SOLACE APARTMENTS - FILING NO. 1

CONSTRUCTION DOCUMENTS

SOLACE APARTMENTS - FILING NO. 1
COVER SHEET

SOLACE APARTMENTS - FILING NO. 1
 SIGNAGE AND STRIPING PLAN

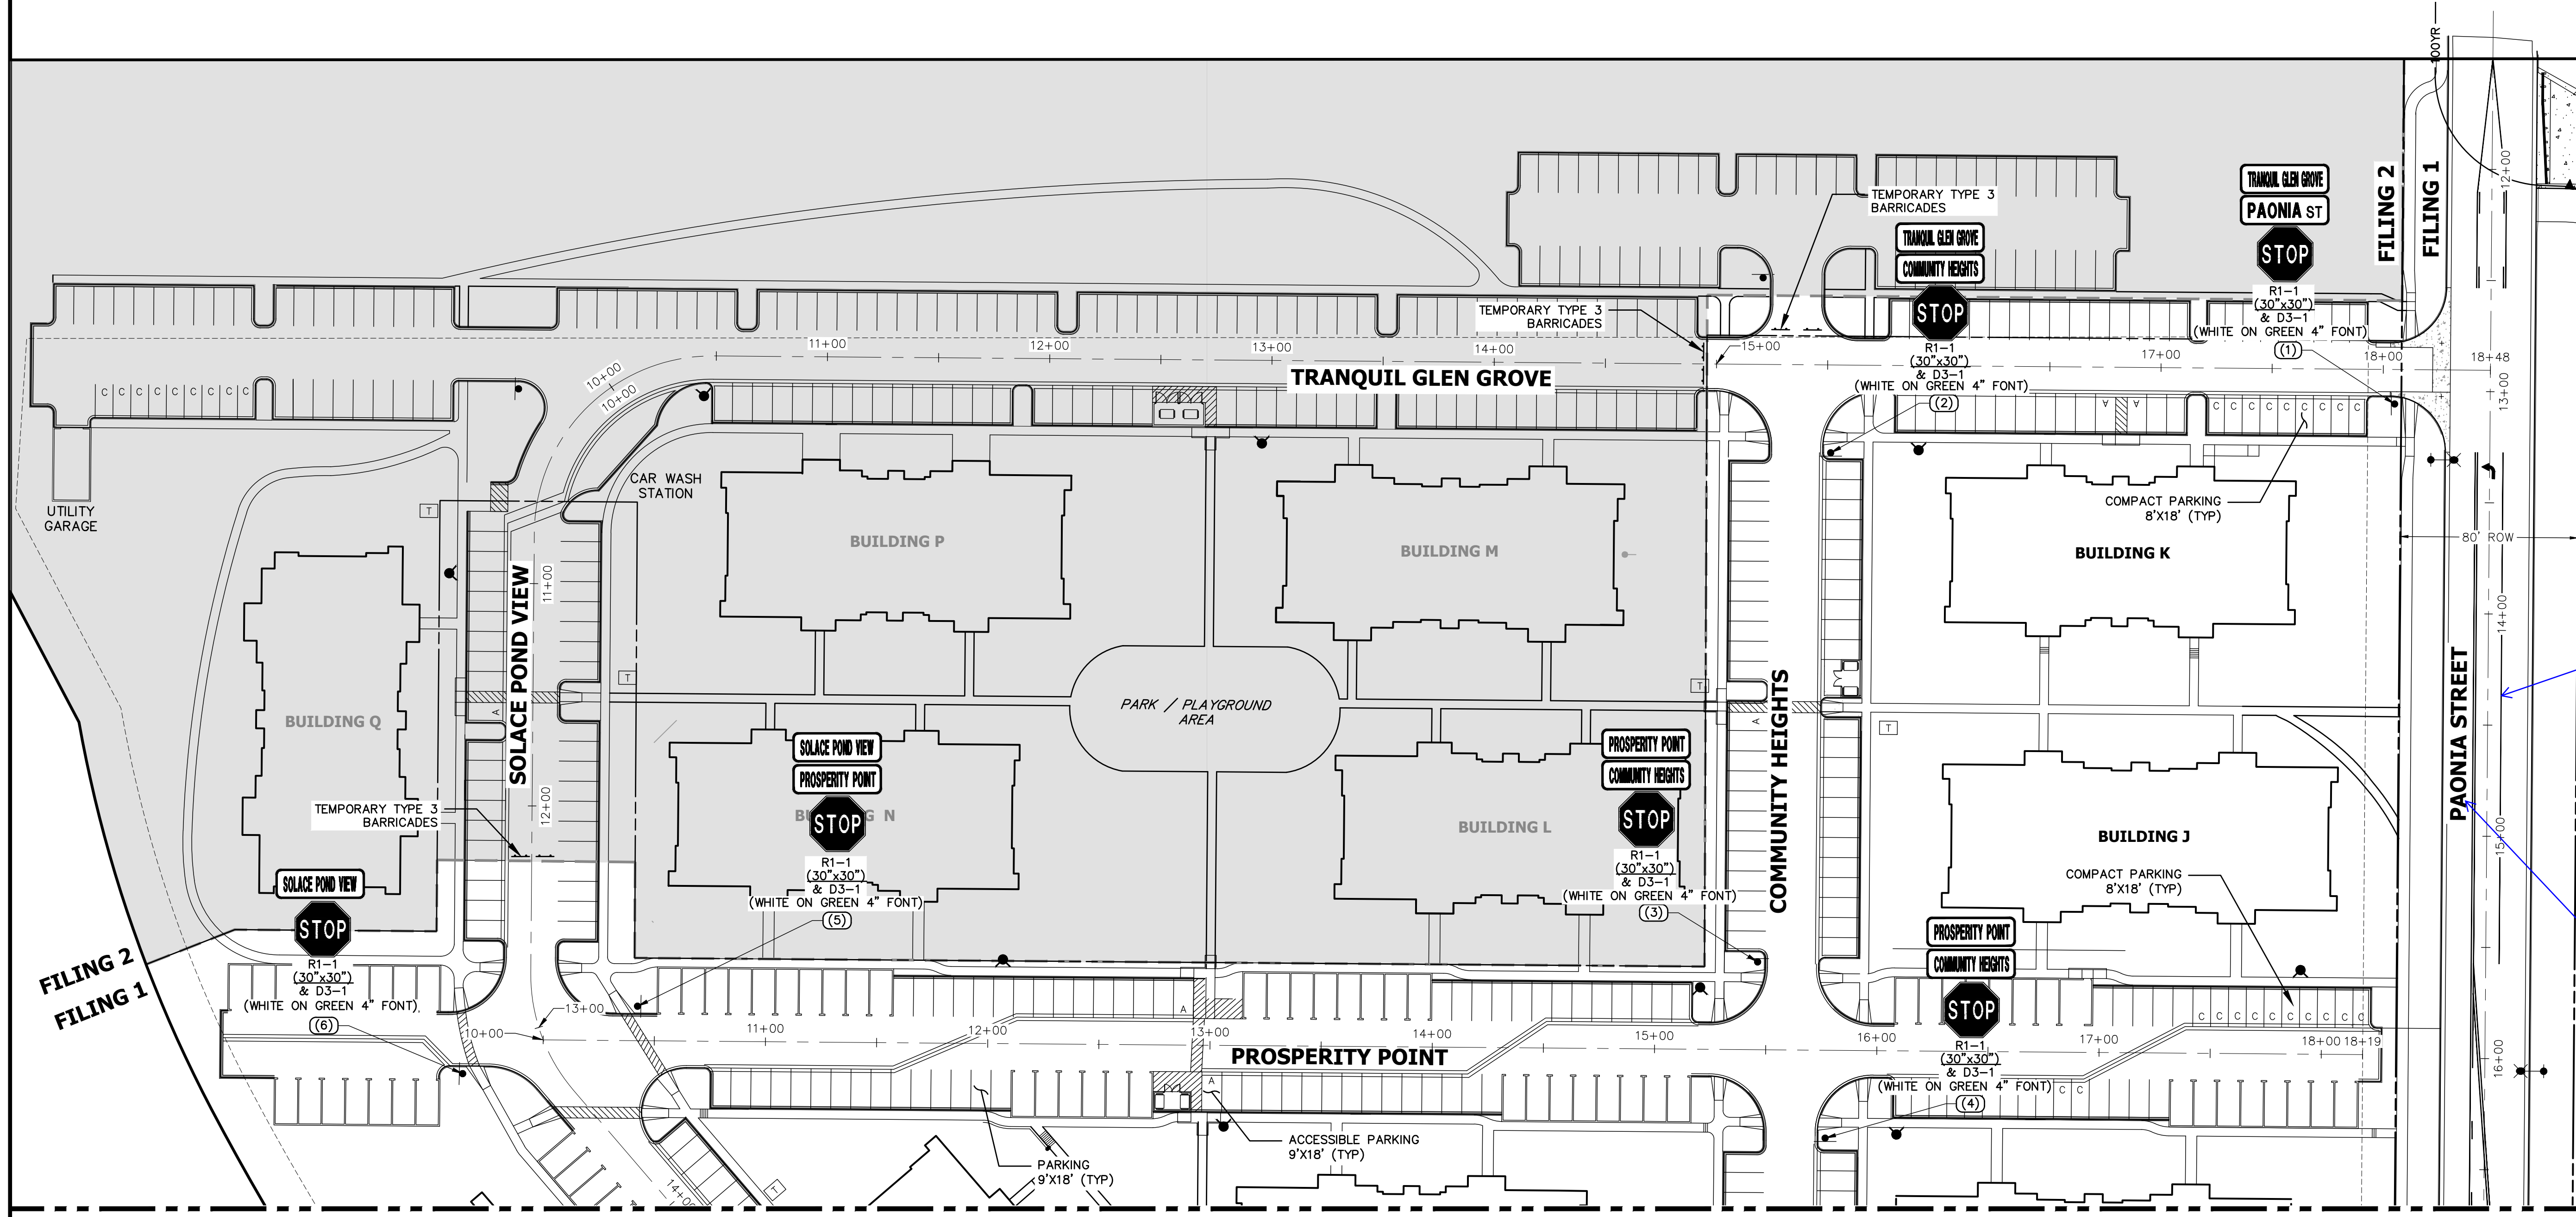
Please provide legend with call-outs of the striping proposed and identify the width, length etc. as done on the Paonia street signing and striping plan (pg47 of 68)

DATE APPROVED: 8/11/11	Parallel Pedestrian Ramp Detail Standard Drawing		EL PASO COUNTY DEPARTMENT OF TRANSPORTATION
APPROVED BY: André P. Brackin	REVISION DATE: 12/8/15	FILE NAME: SD_2-50

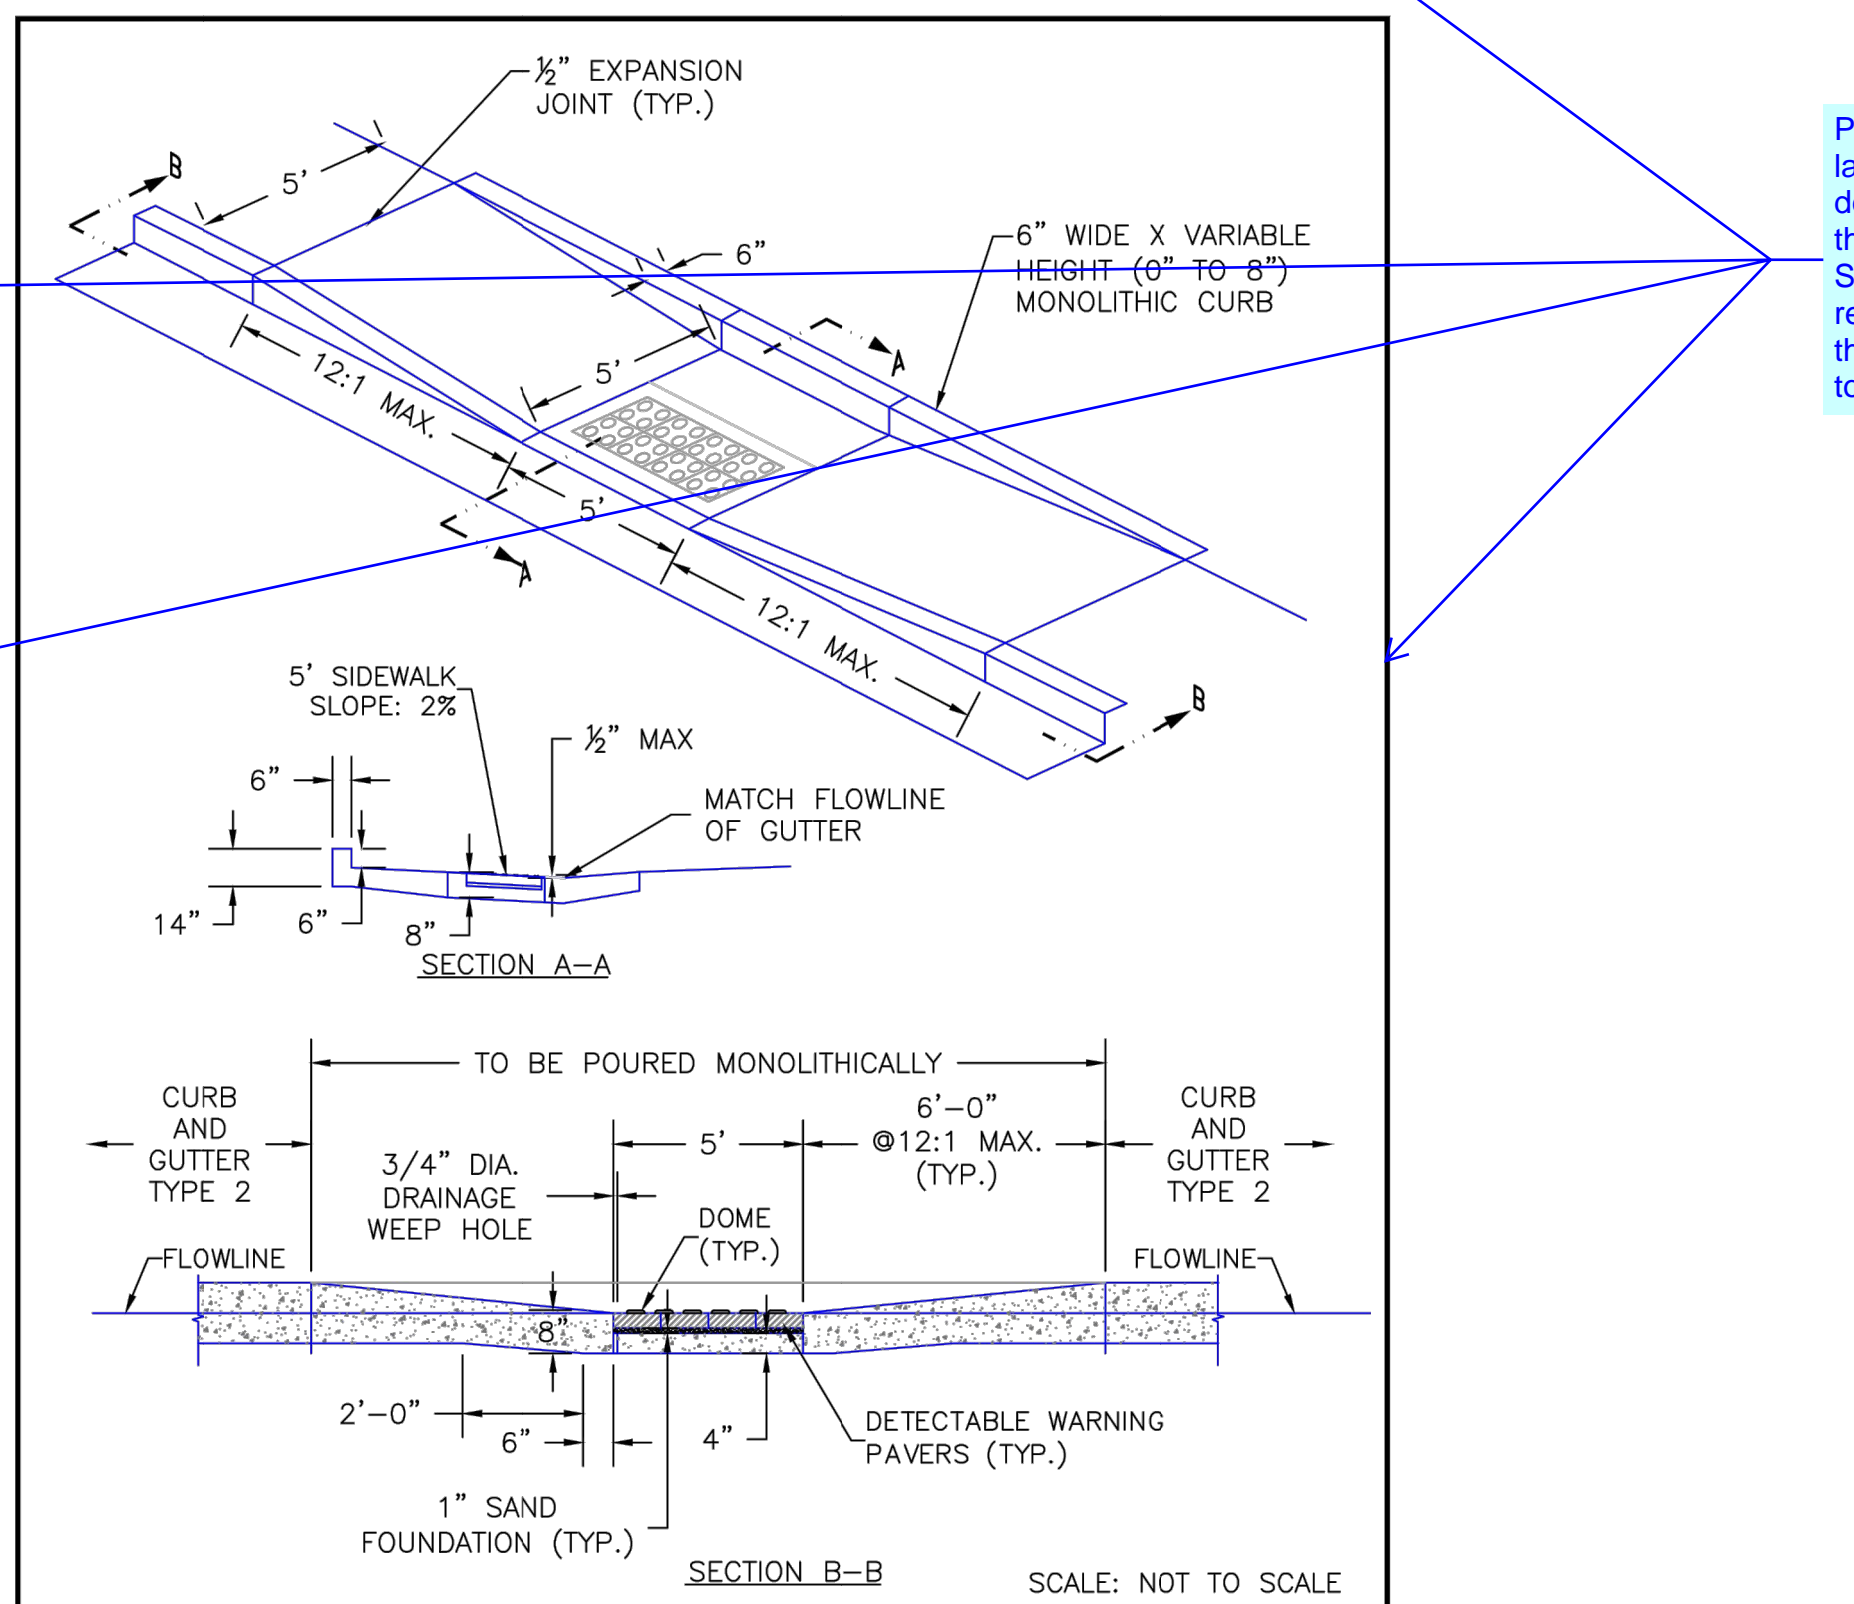
Please replace with the latest county detail.

Please provide the latest PED ramp details (SD_2-40 through 2-42 & SD_2-50) that were recently revised with the adoption of CH6 to the ECM.
